GENERAL AND REVENUE SECRETARIAT.

Repairs to the Coonnattur tank
& the reconstruction of the damaged weir

Reconstruction of the damaged Weir of the Aamattur Inam Tank belonging to the Sri Chamarajeswaraswami Temple at Chamarajanagar

HAND SKETCH

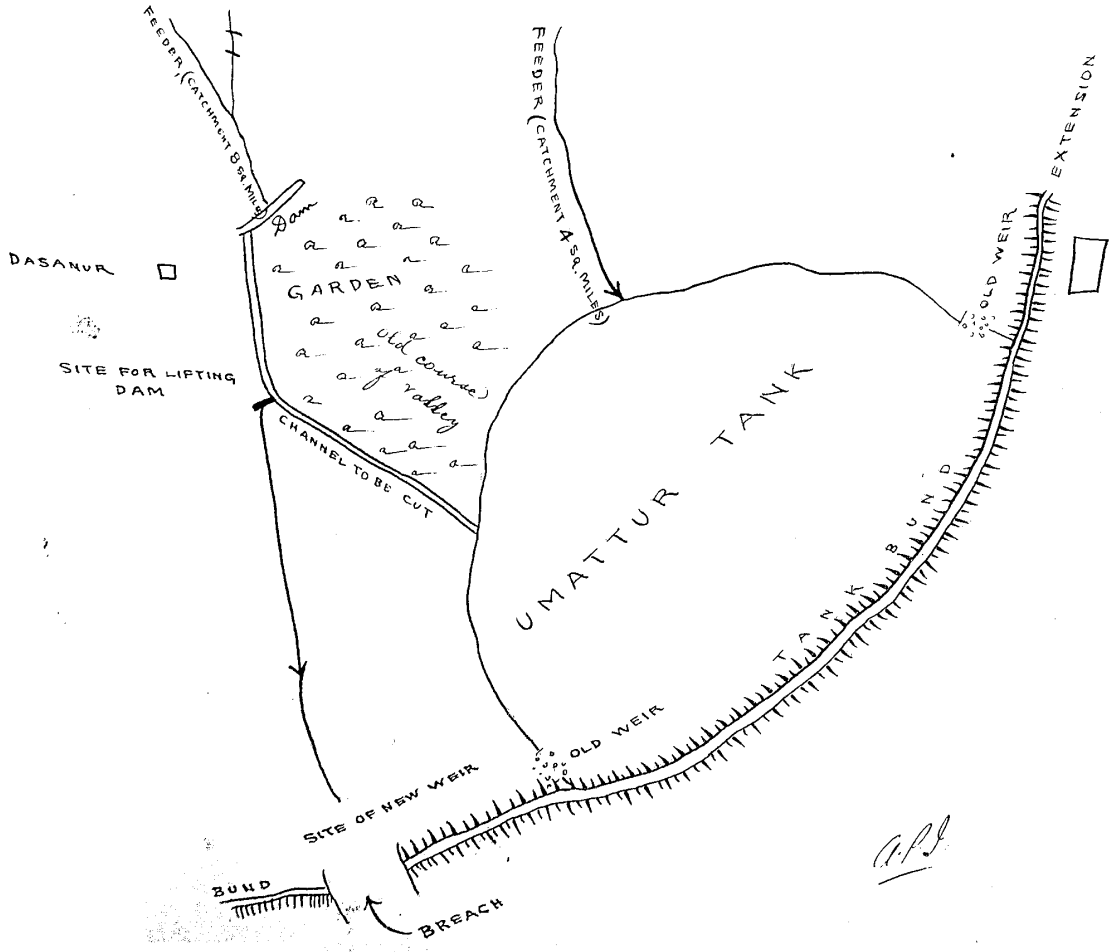
In continuation of this Office No.2005 of 4th April last, I have the honor to forward for orders of Government the accompanying plan and estimate amounting to Rs.17,745 including Establishment and Tools and Plant charges for restoring the Tank Oomathur Tank, Belur Taluk. Vide para 27 of the Engineer's Report, I beg to observe that the point which strikes me most in that the proposed Head works and channel and training works are certain to go to ruin in a very few years. The ryots of Oomathur will never see to their necessary upkeep nor to the proper regulation of the supply to the feeder, and I foresee that in a few years, the money (Rs.18,000) spent on these Head works may be all thrown away.

[illegible] in the new war was washed
